BARANOF INTERBAY STORAGE

DRB Recommendation Presentation #3

Meeting Date 10/19/2016
SDCI PROJECT # 3022095

2.0 REC BOARD COMMENTS + ITEMIZED RESPONSES

West Elevation - Blank Facade Mitigation

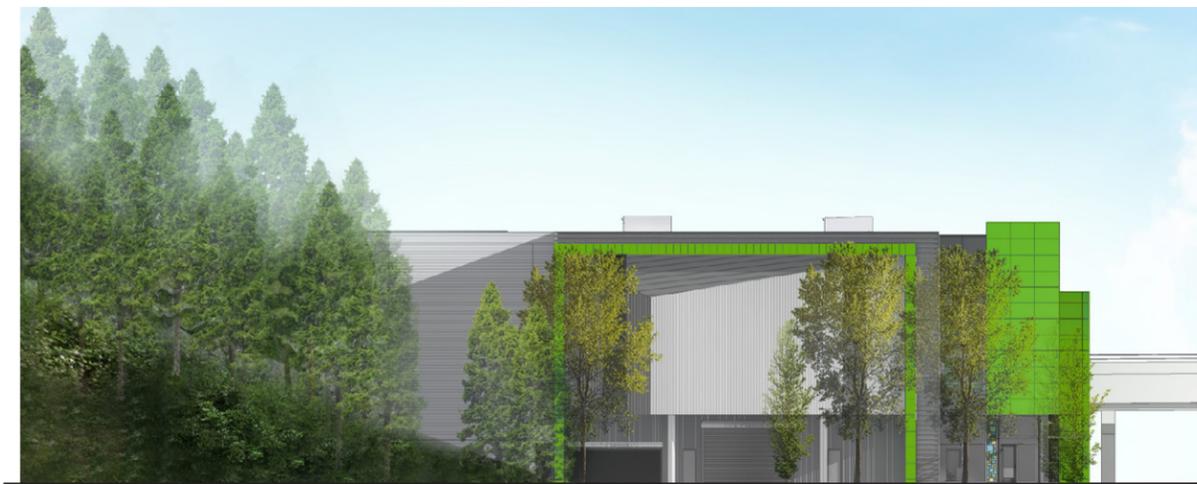
b. Again, the Board supported the architectural concept of the frames or arches on the west elevation, but felt the arches frame or highlight large expanses of blank wall and this expansive blank wall is not acceptable. Instead, the Board wanted to see a substantial response to mitigate blank walls. Add articulation, a mural, or use material application or super graphics to create a sense of place. Look to the mural at CVS (at 531 Queen Anne Ave N) for inspiration.

We are proposing to break up the blank walls with a bold, triangular and trapezoidal composition. In using different colored panels with different textures, a sense of great depth is created in the wall face. Each location under a green arch is configured to the individual location on the building, including the south and north facades. Trees and major landscape elements are composed to highlight these panel configurations and to work with the textures of the façade as it integrates into the 15th Avenue streetscape.

LANDSCAPE OPTION #1 / PLANT PALETTE / SHRUBS, GRASSES, PERENNIALS

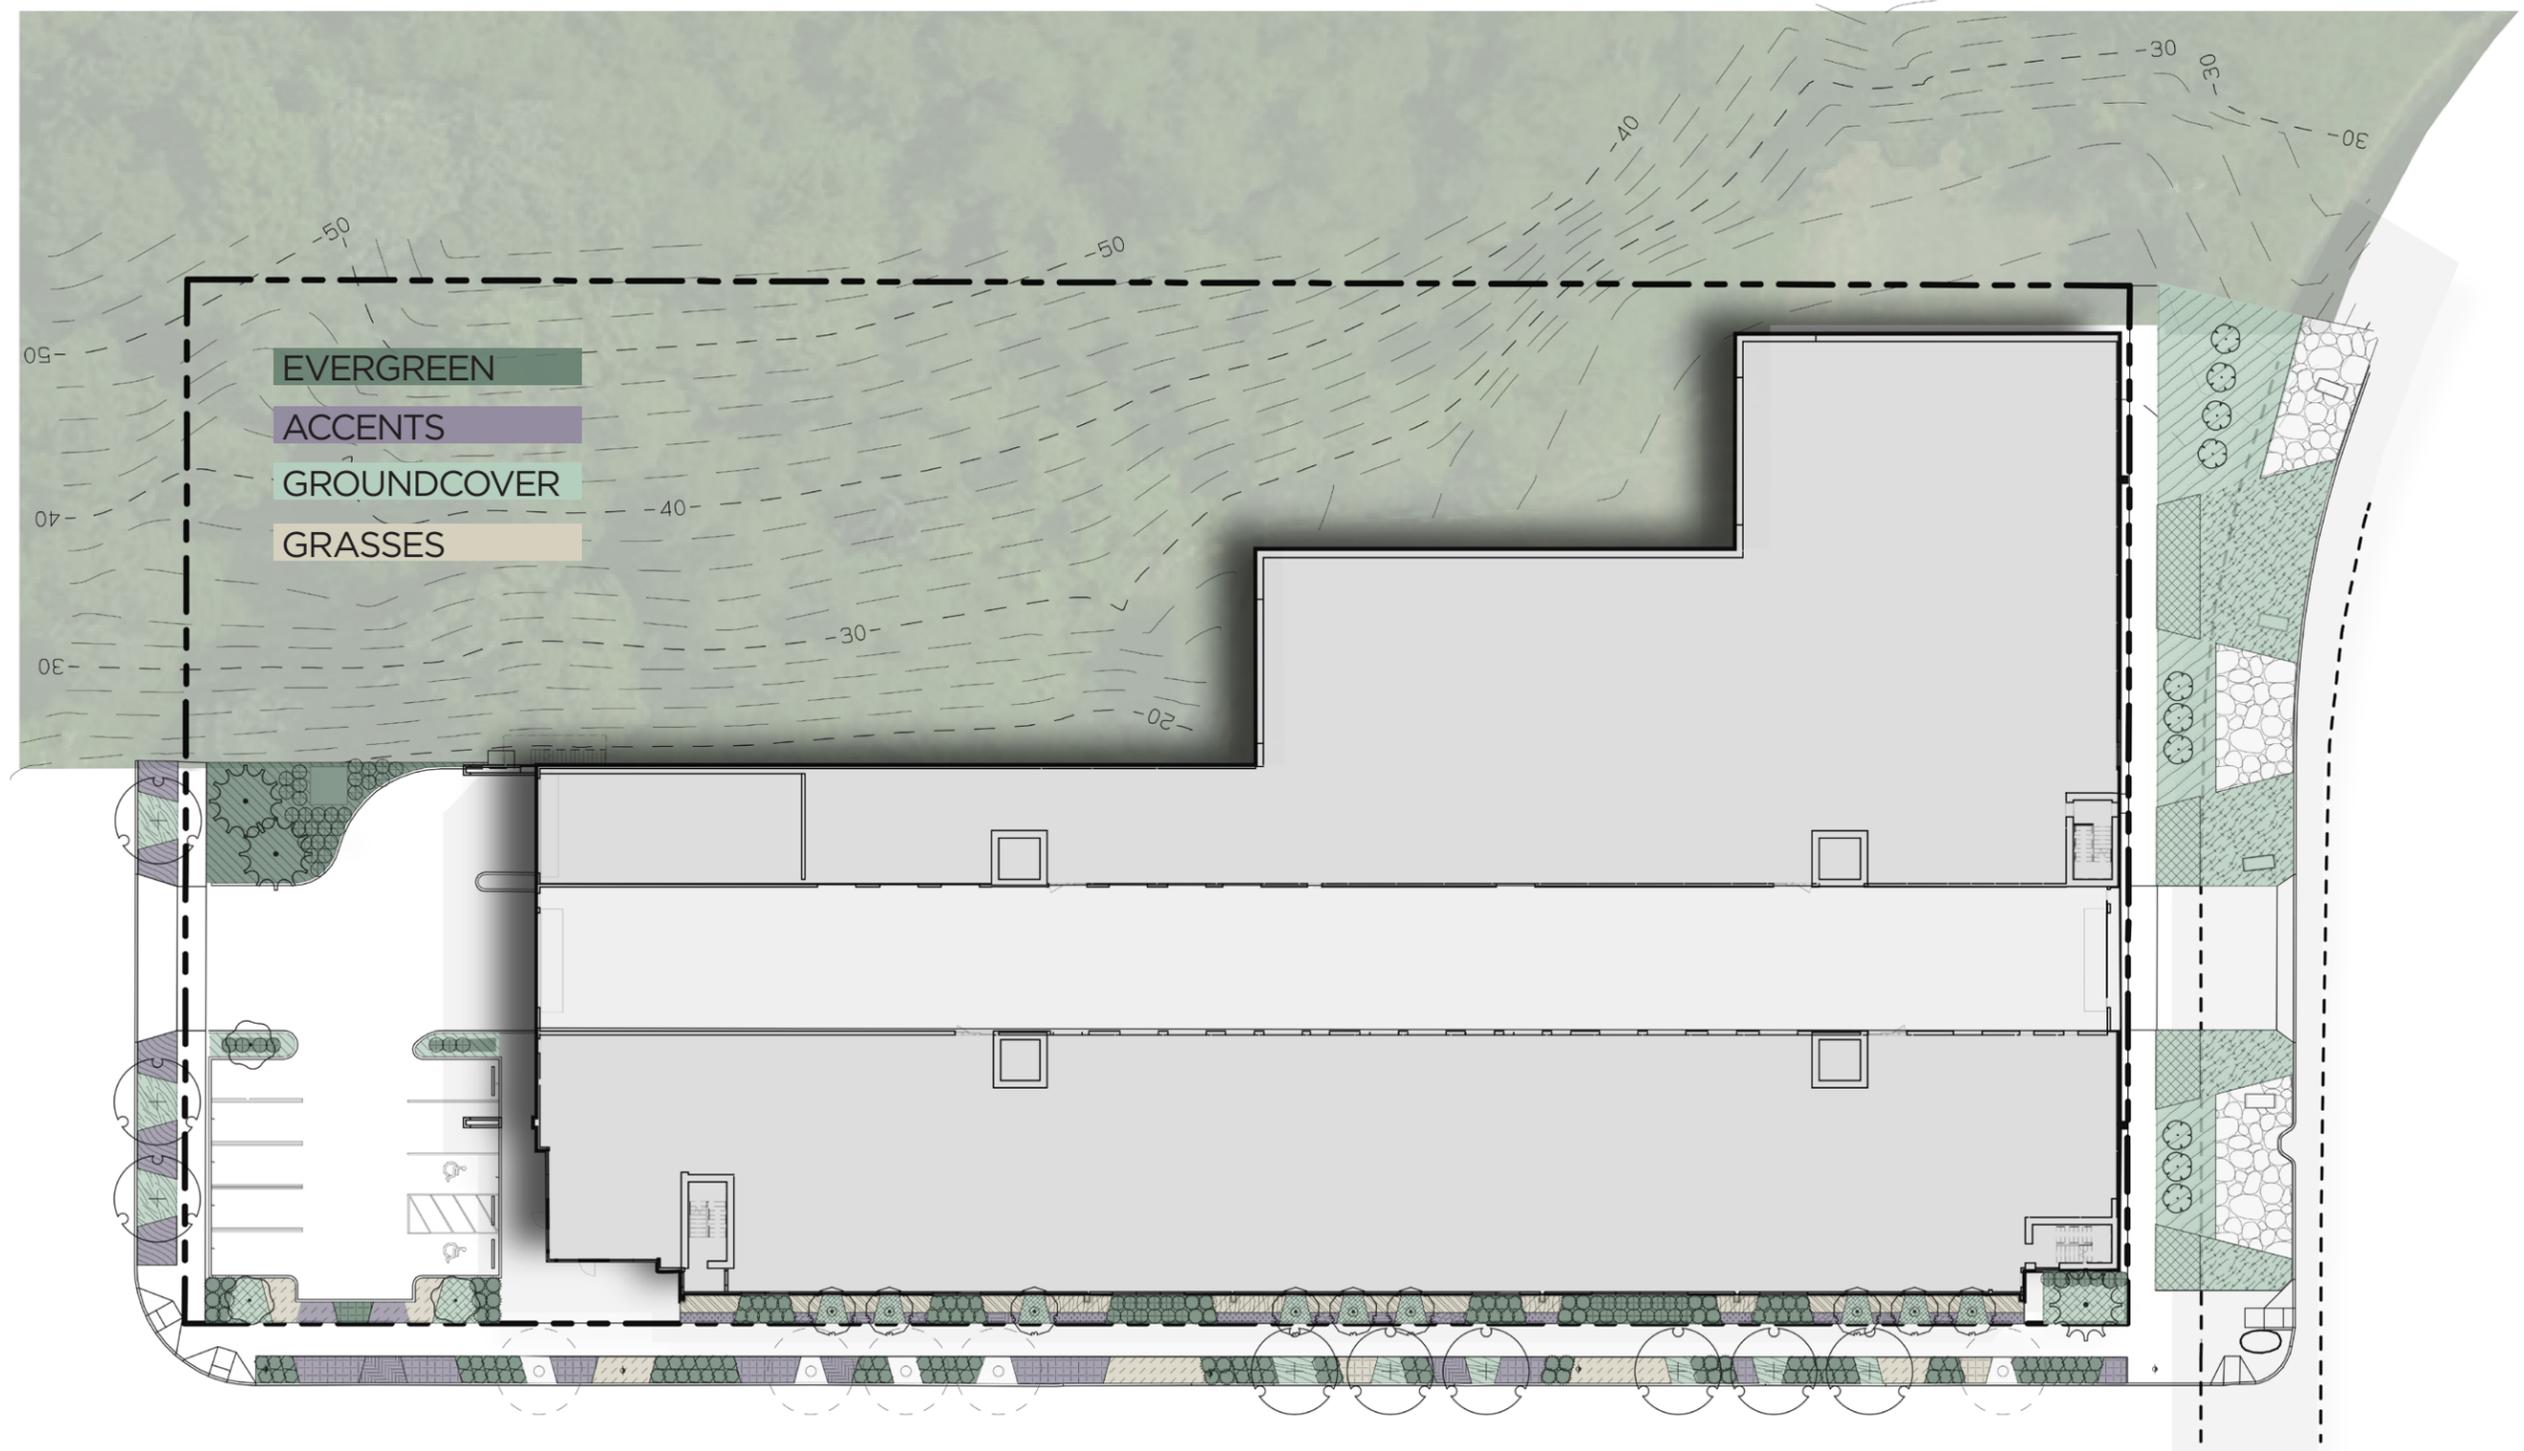
a. The repetition of columnar plantings (Irish Yews) was not supported by the Board. The Board reiterated their guidance for a landscape plan that includes native plantings, a variety of plantings and scale, and seasonal color. Eliminate the monotony of the landscaping along 15th and provide a landscape concept that contributes to the architectural concept and creates a sense of place.

The planting includes a variety of planting that includes native and adaptive species that are appropriate to this bioregion, and specifically this site. The selection provides a range of color and seasonal variety consistent with the guidance provided.

ENTRY AT LOBBY (NORTHWEST CORNER)

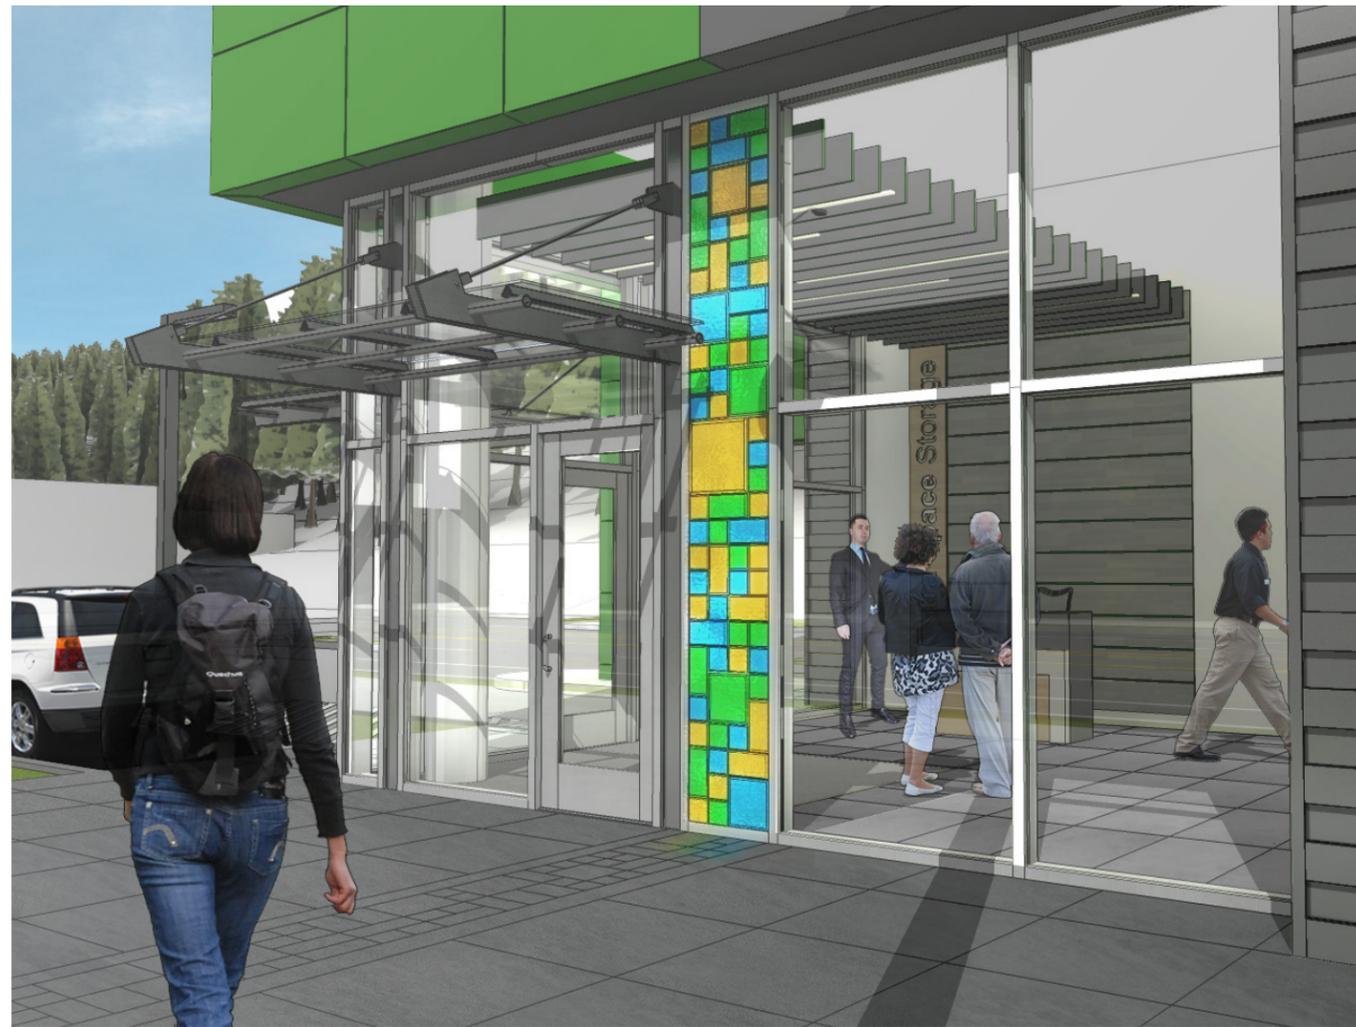
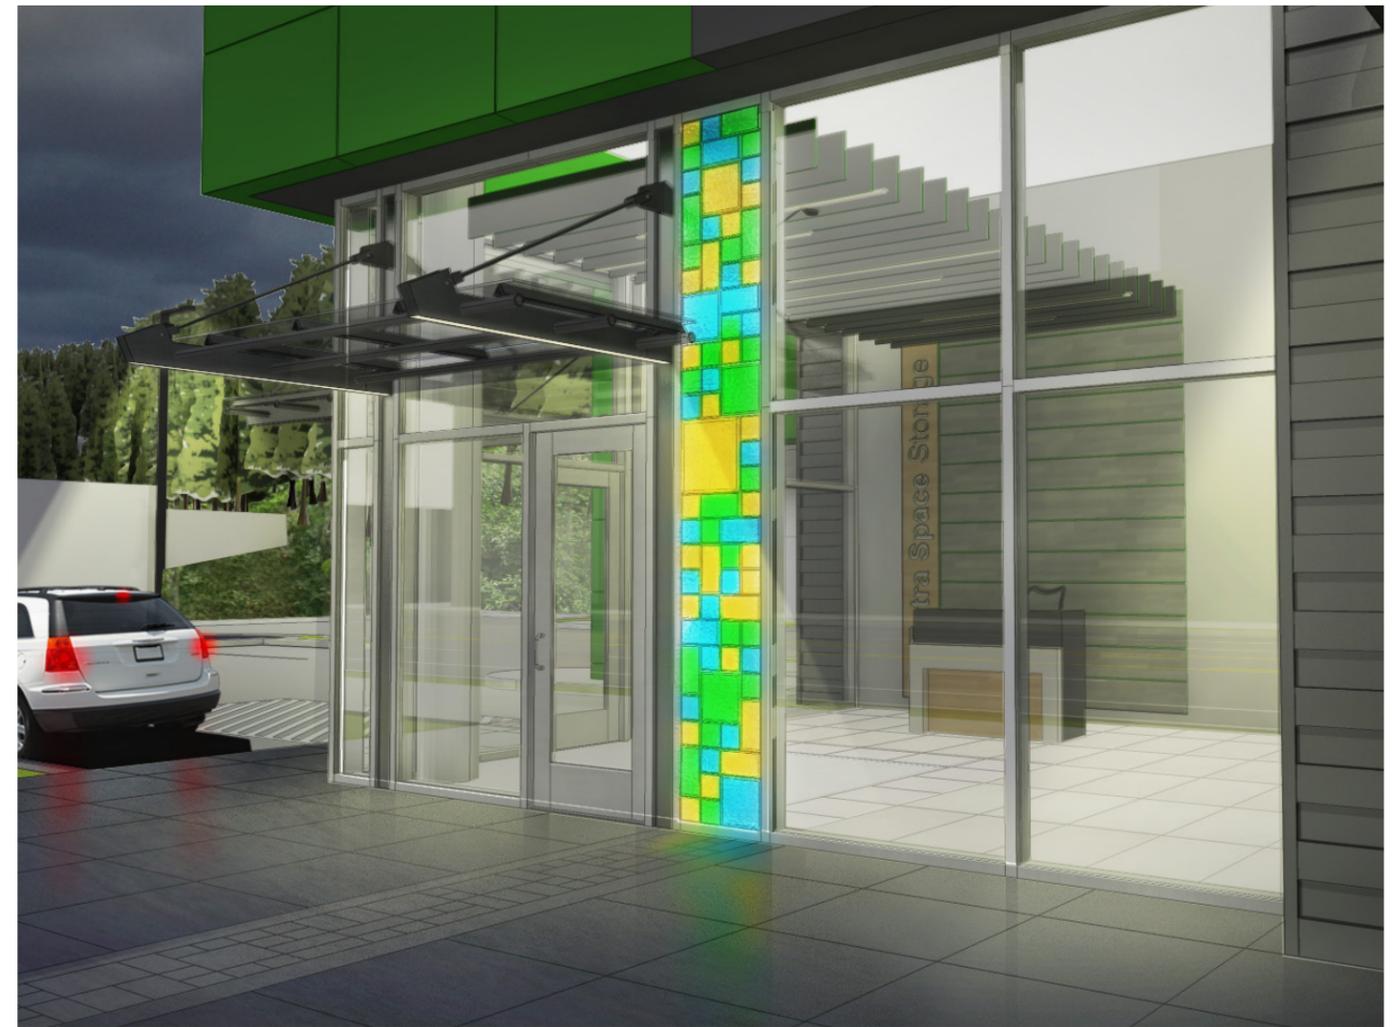
a. The Board again supported the use of the glass tile from the current tenant, but would like to see more tiles used in a more artistic composition that is better integrated into the entry sequence. Increase the amount of tile and better integrate them into the entry sequence.

The volume, composition, and integration into the entry sequence have been revised per the board guidance. In addition, street level paving pattern and interior floor patterns have been designed to reinforce the glass element. It should be noted the glass tiles will be back-lit after-hours.

Site Plan - Transformer & Gas Meter Locations

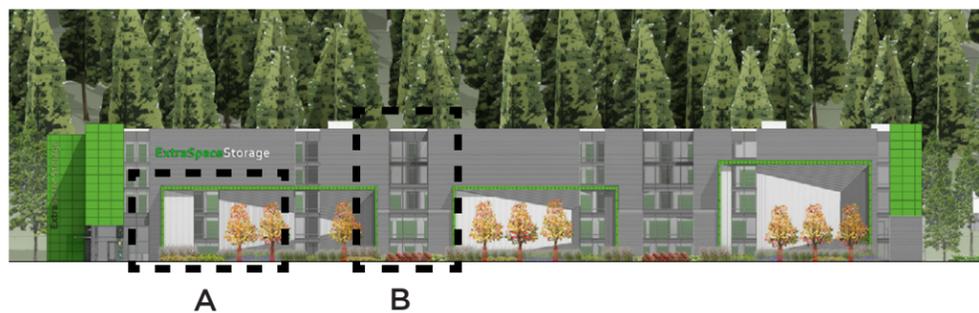
c. The southwest corner of the structure is notched, with an additional five-foot setback. It was noted that this area will contain some utilities such as a gas meter. The Board requested additional information to understand the treatment of this area. Include in the next Recommendation packet street level perspectives of this area including the utilities.

The requested information for the street level screening of the gas meter at the Southwest Corner and the transformer at the Northeast corner has been included. Both are shown with significant landscape screening.
